# **JAFNPP**

## **IMPROVED STANDARD TECHNICAL SPECIFICATIONS (ISTS) CONVERSION**

**ITS: 3.8.5**

**MARKUP OF NUREG-1433, REVISION 1, BASES**

RAI  
3.8.6-1

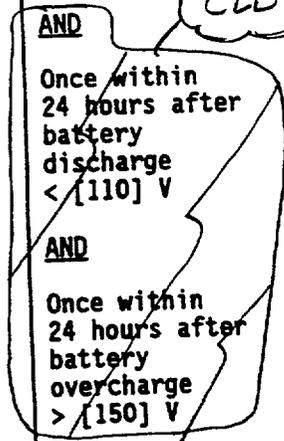
SURVEILLANCE	FREQUENCY
<p>(M4) (1.9.E.1) (1.9.F.1) (L2) (MS)</p> <p>SR 3.8.6.1 Verify battery cell parameters meet Table 3.8.6-1 Category A limits.</p>	<p>7 days</p>
